| Luard Conservation<br>67 Salford Avenue<br>London NW10 4EP<br>+44 (0)20 8061 7544<br>+44 (0)7963 741 117<br>info@luard-conservation.com | The Elms, Fitzroy Park |  |  |
|   | EW/G.21                |  |  |

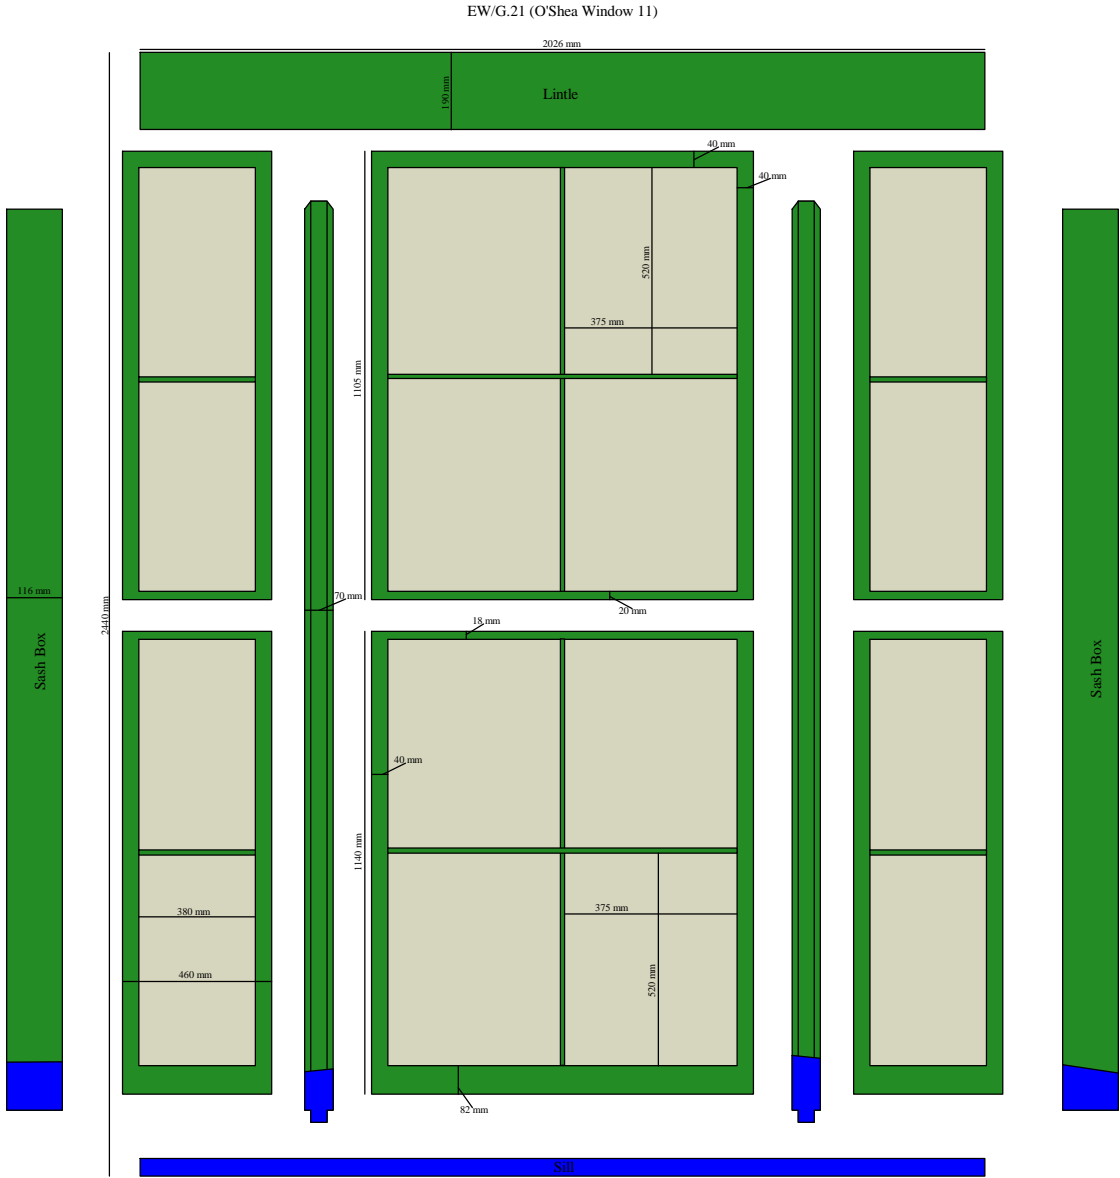
Missing timber

Existing timber requiring refurbishment

Timber recommended to be replaced

The shade to EW/G.21 exists but is in bad condition and will require substantial repair and replacement.
